Design Response Conference 10/19/2009

Building A Articulation

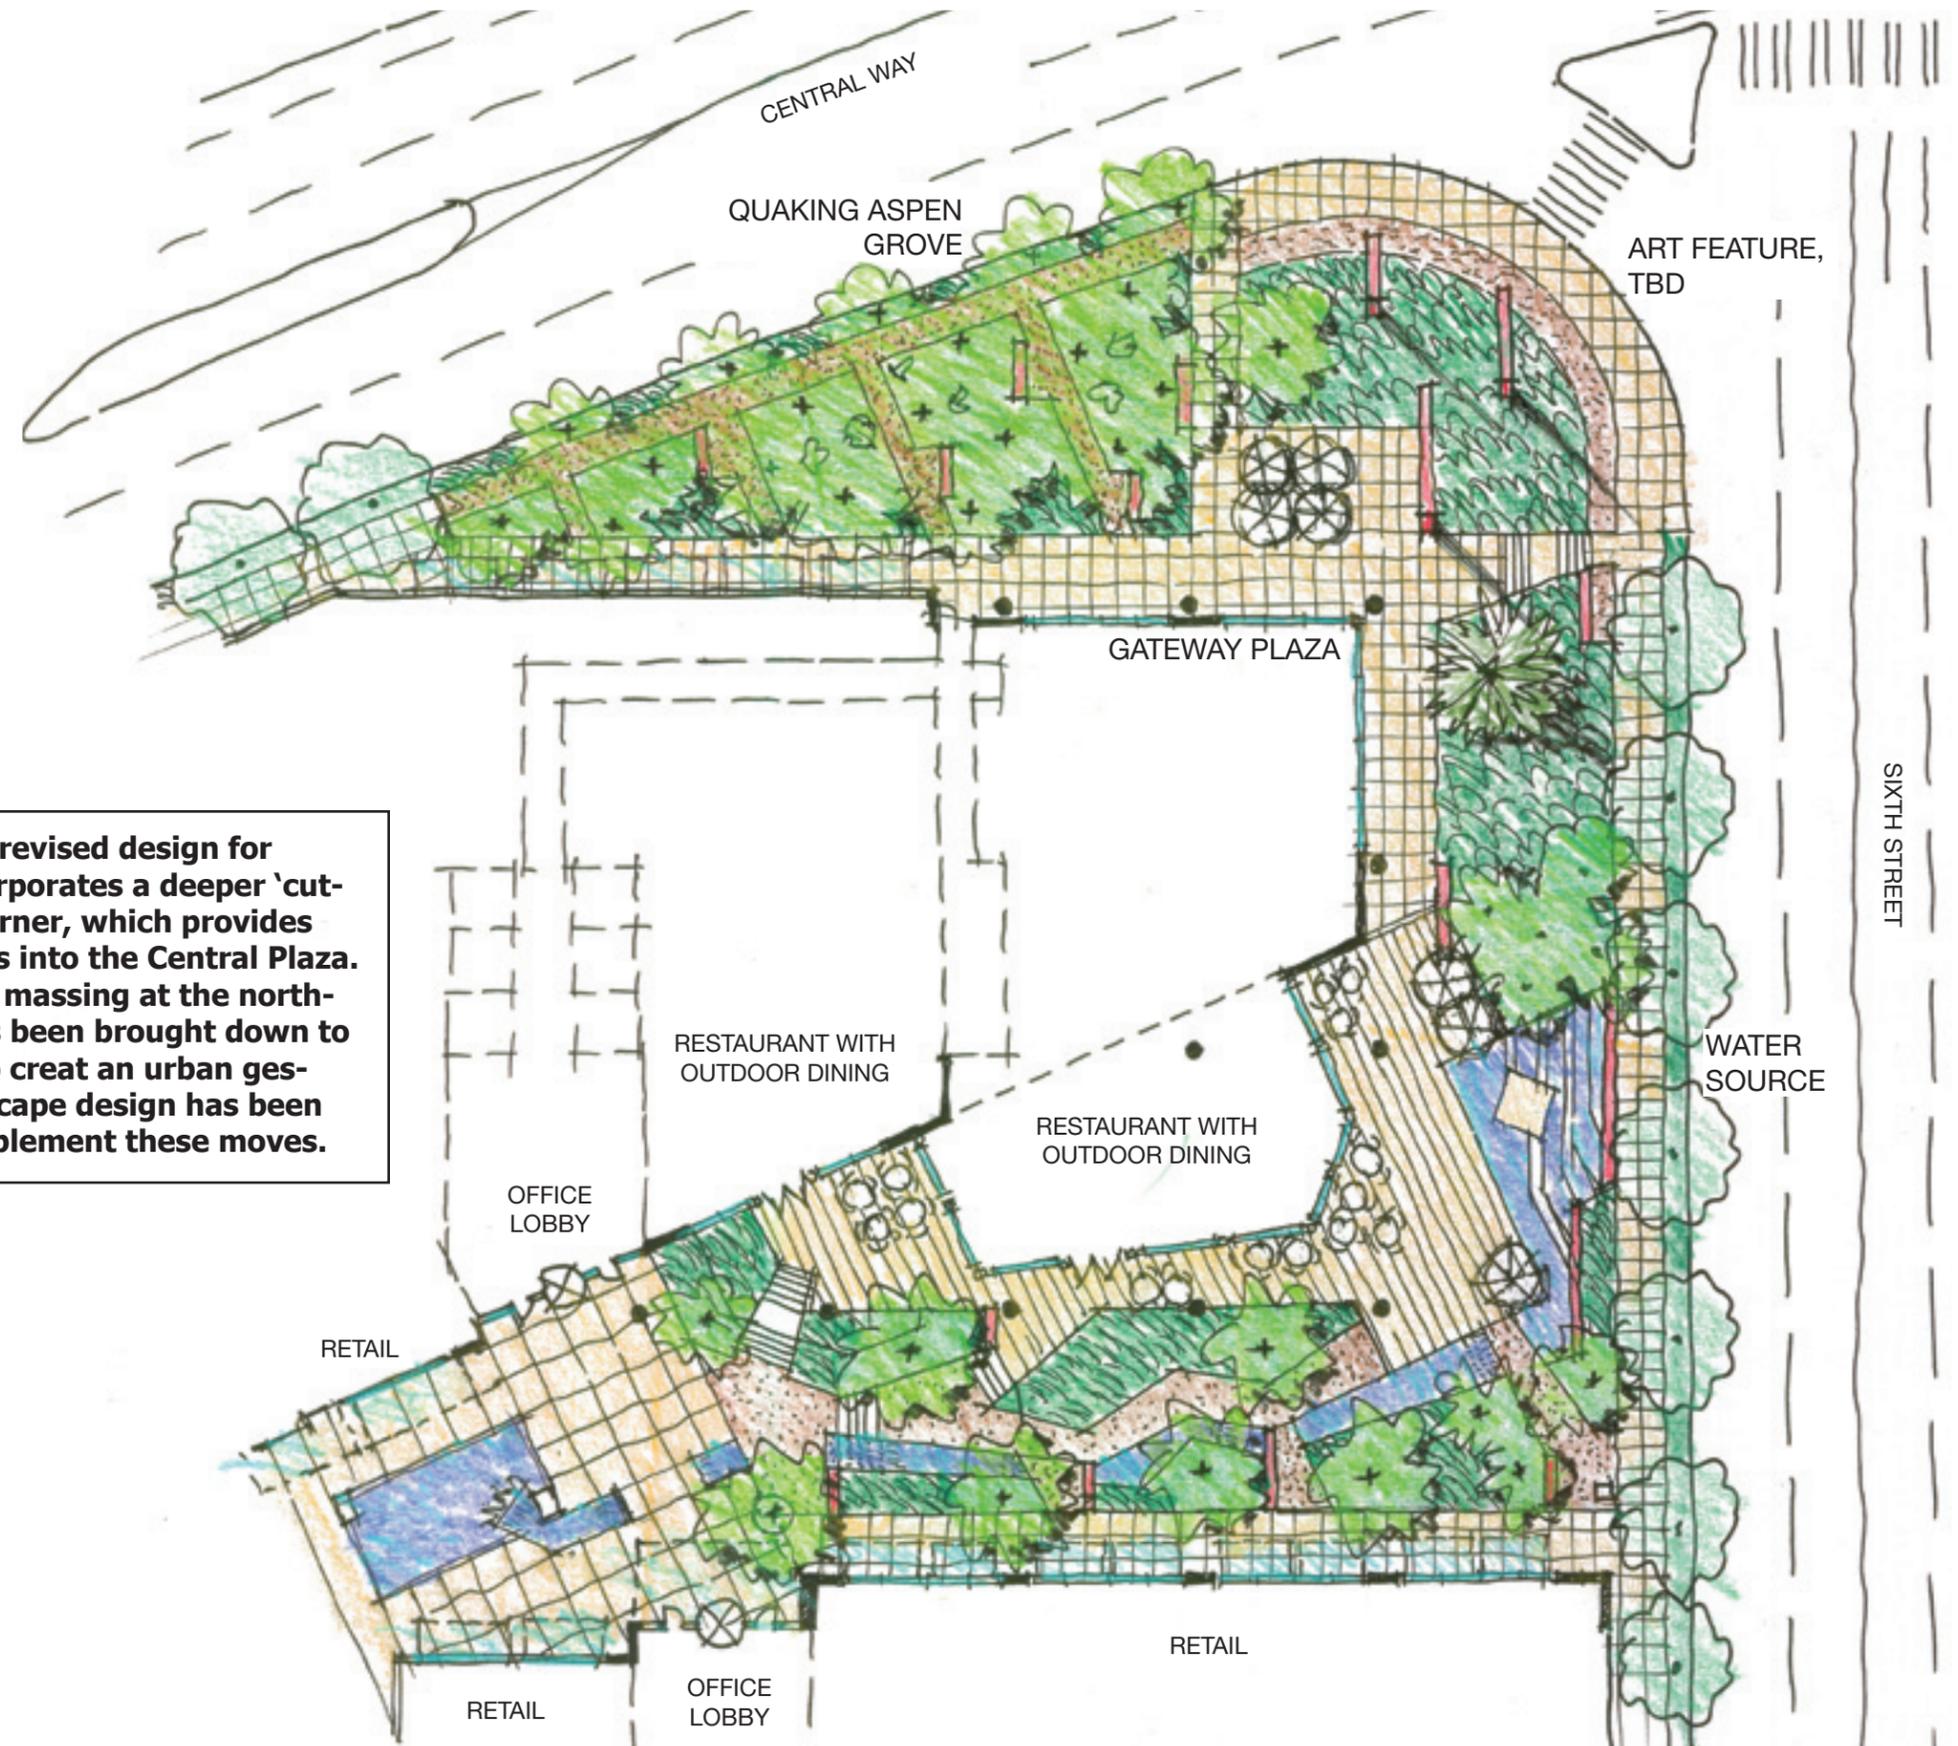
DRB comments: 1. Gateway Garden (a, b, c & d) – Need more design on gateway concept (relationship of plaza to building), need updated drawings and landscape plan for this area. Need more of an "ah ha" moment! Maybe more symbolic rather than an actual entrance... this is still a concern.

2. Triangular Lot public space...see gateway garden comments.

Response: The revised design for Building A incorporates a deeper 'cut-away' at the corner, which provides increased views into the Central Plaza. In addition, the massing at the northeast corner has been brought down to the sidewalk to create an urban gesture. The landscape design has been revised to complement these moves.

A-A
alternate 1

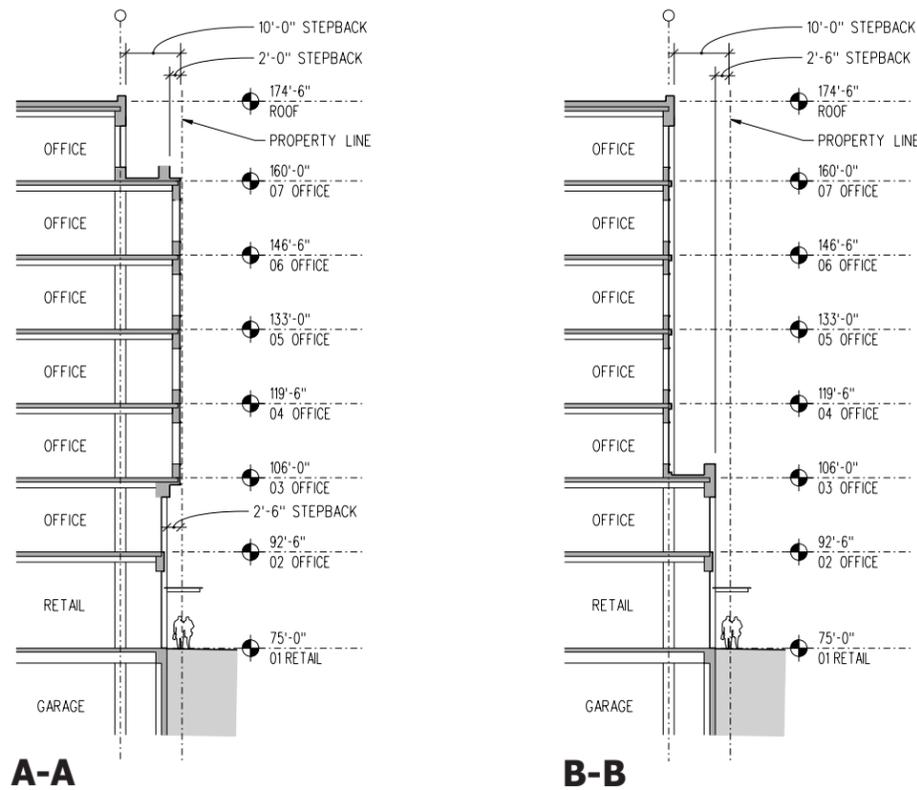
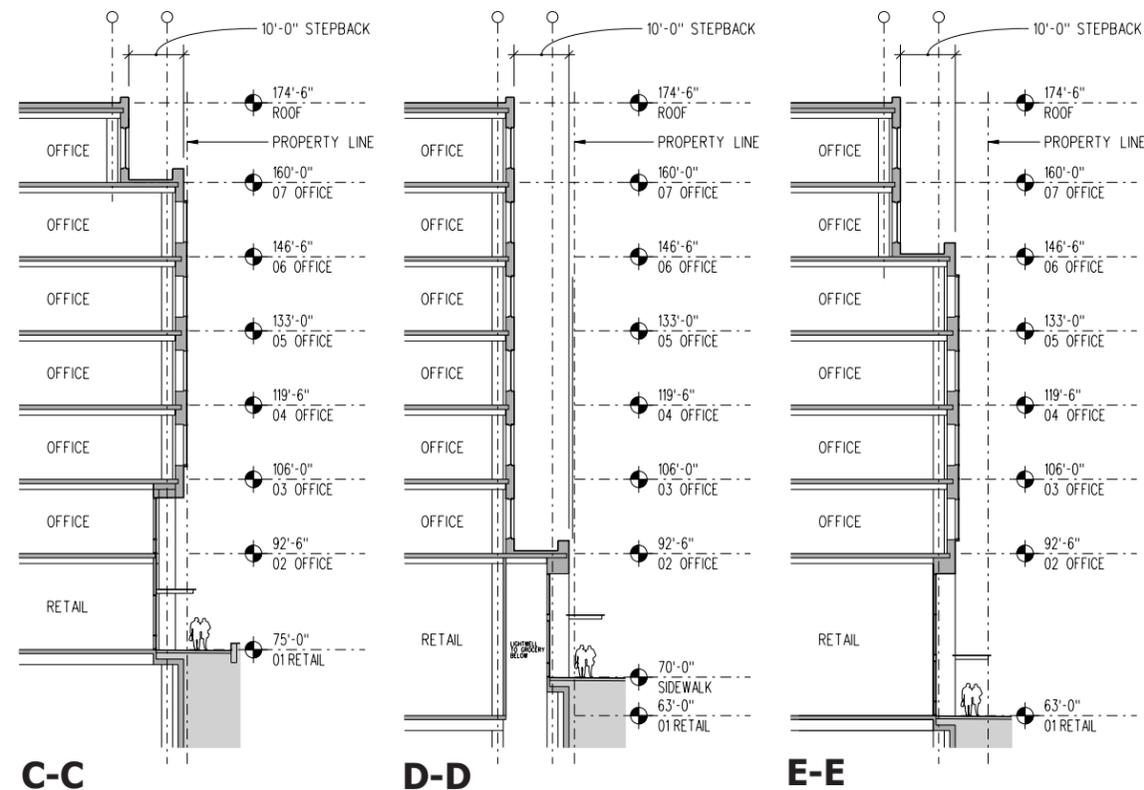
DRB comments:

- 1a – Ground level setbacks from street – relates to previous conversation.
- 1b – Retail/restaurant uses - concern
- 1c – Details visible at different movement speeds – don't have at this time so it's a concern
- 2b – Upper levels step backs: a concern remains about whether design meets the intent of this guideline. This shouldn't just happen in one area of the building.

Response: The revised design for Building A incorporates the stepback along the predominant portion of the Central Way elevation. It is interrupted only in order to satisfy the requirement for horizontal modulation.

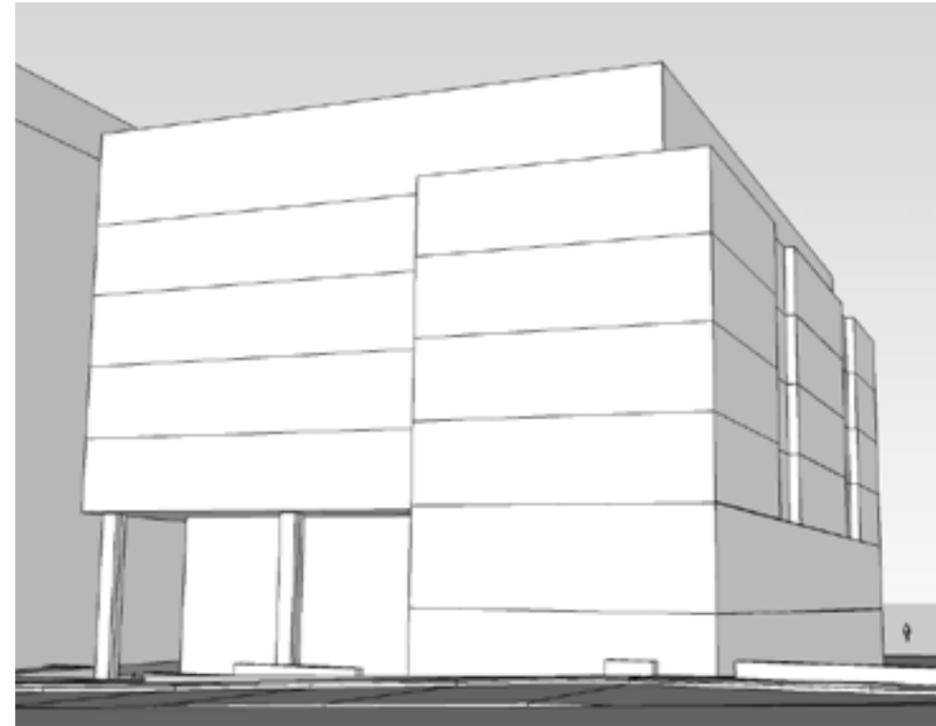
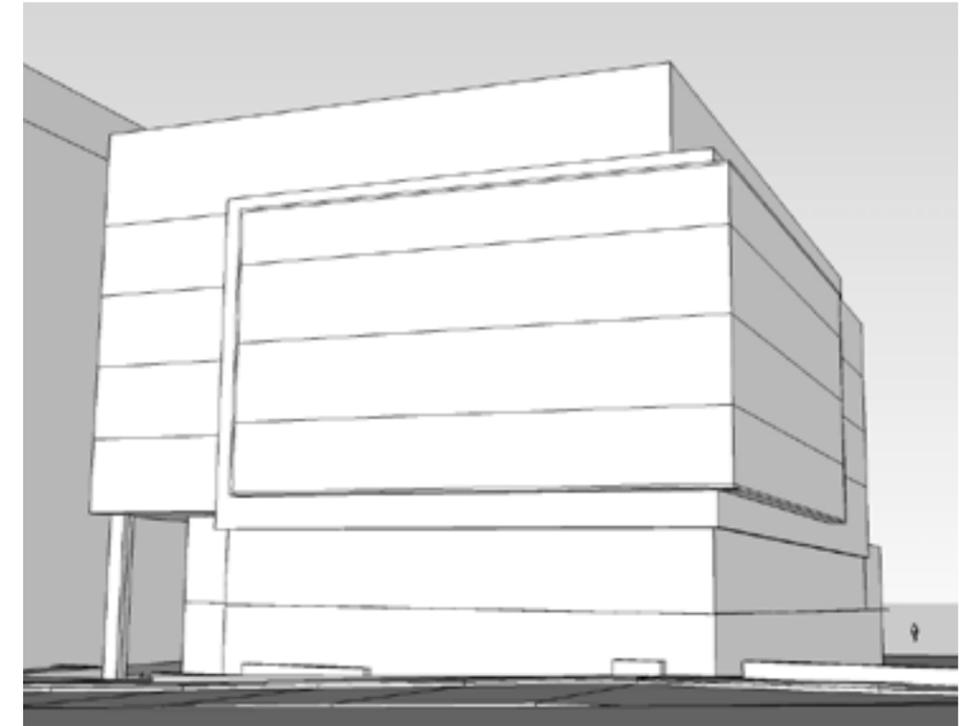
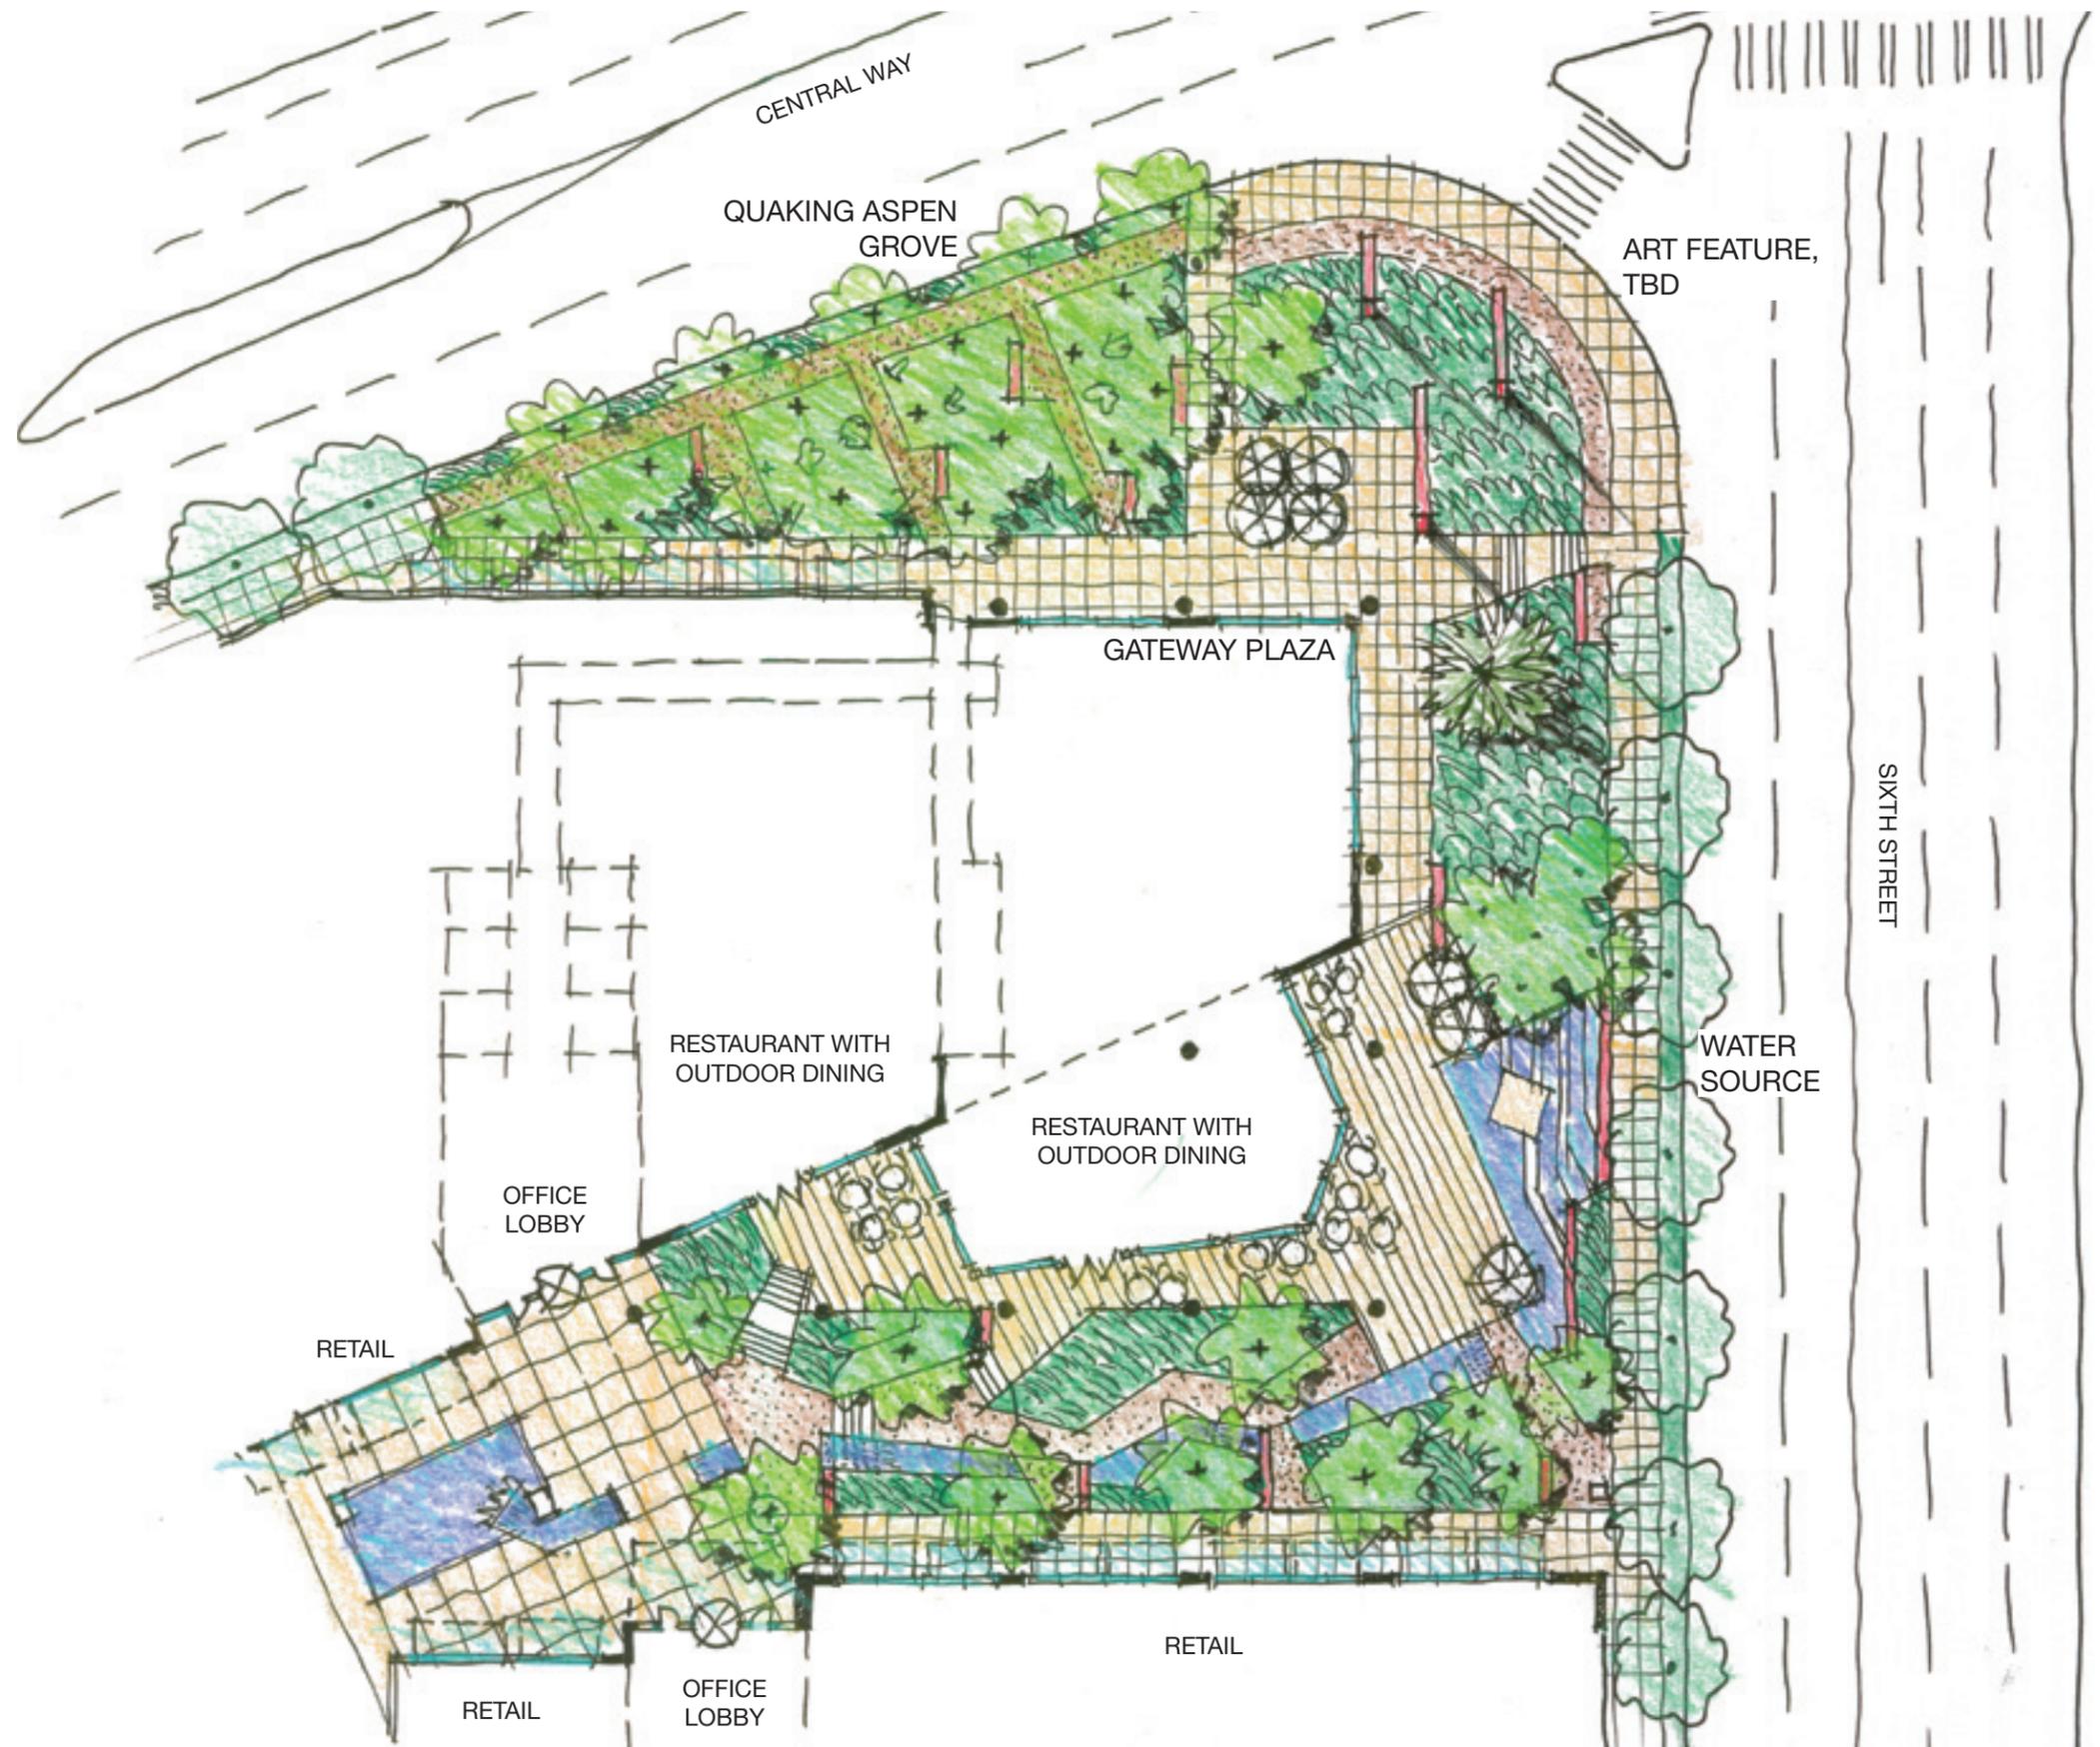
DRB comment: Atrium/Breezeway Space – see previous discussions of 1 and 2. The view may be one that indicates a connection to the corner of 6th and Central Way (see examples on pg. DG-23). May be drawn in from intersection (doesn't have to be a straight line).

Response: The revised design for Building A incorporates a deeper 'cutaway' at the corner, which provides increased views into the Central Plaza. The landscape design has been revised to complement this move.
